Re: 18 Westbrook Place, Rotorua - Val. No. 06562/107.03.
Legal Description: Lot 3 DPS 81300.

As Built Floor Plan – Amendments during construction.

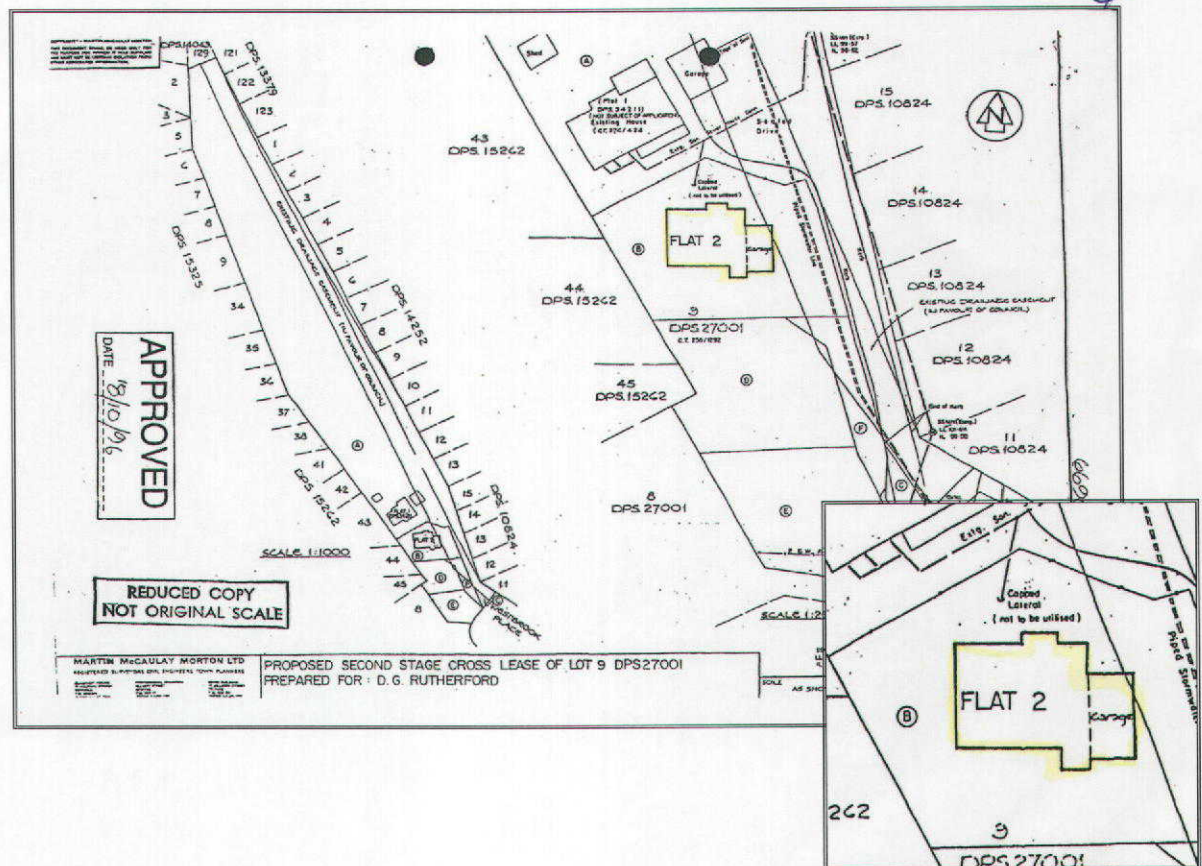
The original porch area beside the garage is enclosed to form an entry, which extends out approximately 1.8m from the wall. The roof line and roofing material matches the main dwelling in style, age and condition.

The weatherboards are an exact match with the remainder of the house, indicating they are from the same batch. The boards are staggered with full lengths across the front of the entry extending down across the bathroom and bedroom. The boards across the gable of the roof line over the stairwell and entry are also full lengths, again, as exact match to that of the adjoining garage and house. The entry door joinery installation is to the same joinery profile as the remainder of the house.

The floor tiles are also an exact match to those in the dining area where the conservatory window was installed, which was completed during construction. It is reasonable to conclude the linings and finishes were all completed at the same time.

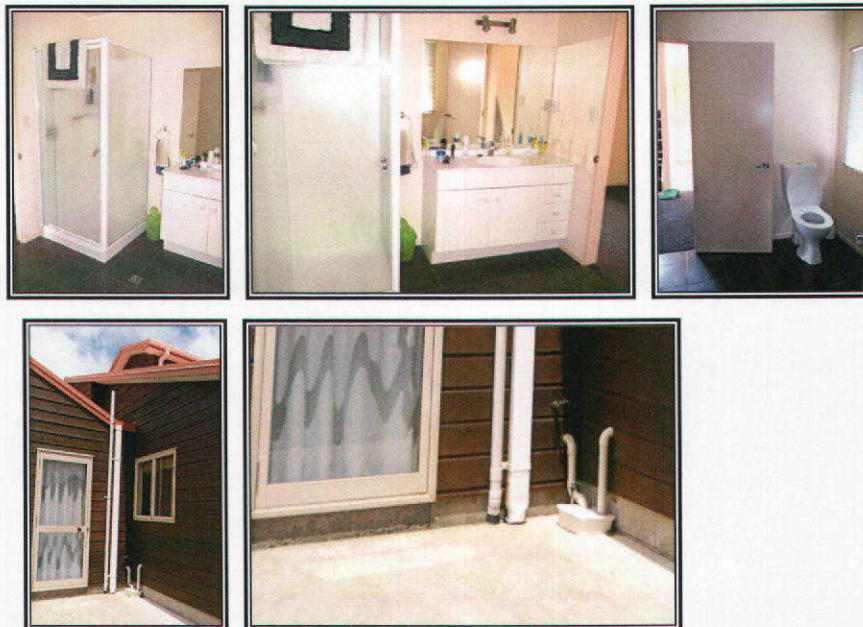
The upstairs bathroom toilet pan and vanity have been inverted. Fittings are modest and match those of the ground floor bathroom. There is no benefit from inverting the fittings had they already been installed as indicated on the plan, given the significant work and resultant repairs necessary had the WC been relocated subsequent to original installation. N.B: With excess space within the room for installation to either wall the change would simply have been a personal decision during construction.

The alteration to the ground floor bathroom consists of the vanity being relocated beside the shower. The toilet pan, shower and floor wastes are installed as originally indicated. The laundry is relocated in the garage, a logical change following the decision to attach the garage to the house. Instead of being located in the centre of the house, the laundry is now beside the exterior P.A door which is more convenient to the washing line. Plumbing and drainage discharges into the gully trap which also serves the kitchen. The fittings to the ground floor bathroom match those of the upstairs, with floor wastes installed where originally intended.

First Floor

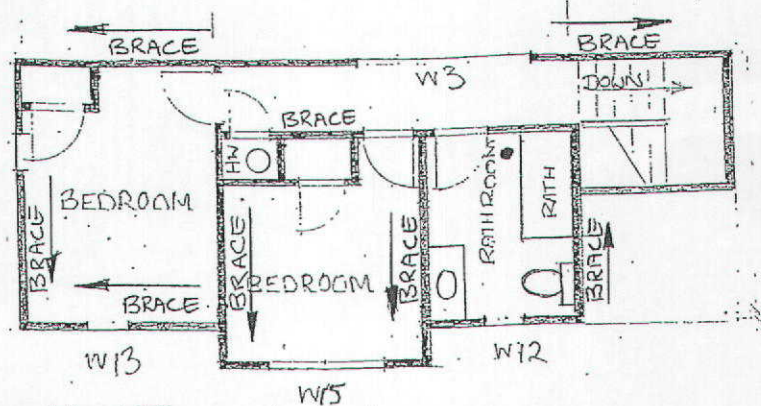
The HWC was originally indicated as being located beside the entry door, though is installed in a first floor cupboard above the bathroom. The ground floor cupboard has no indication of having ever housed the cylinder, with no patching to ceiling linings or floor coverings. Patching to cupboard linings is not a high priority, so it would be anticipated any penetrations for overflow pipe would still exist, had the cylinder originally been installed in the intended cupboard. The cylinder is dated 3/1995 and is the original cylinder from construction.

Ground Floor

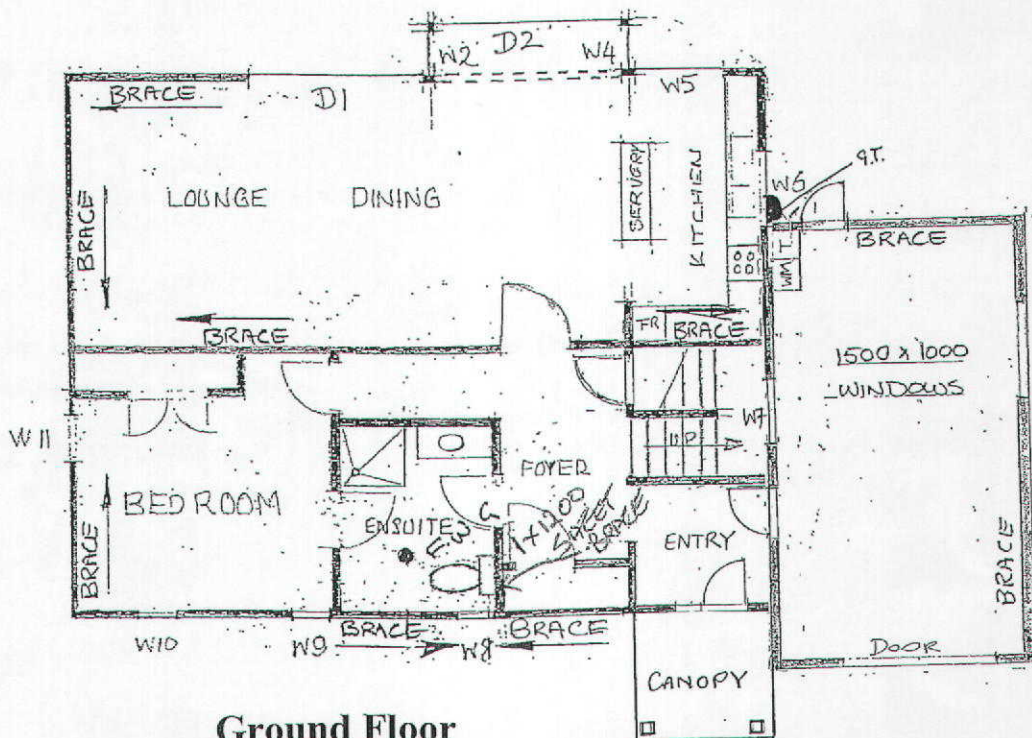
1. Garage and porch attached to dwelling:

The original plans indicate the garage as a separate building, though was instead built attached to the house. The concrete floor has been in a single pour up against the house wall and is stable.
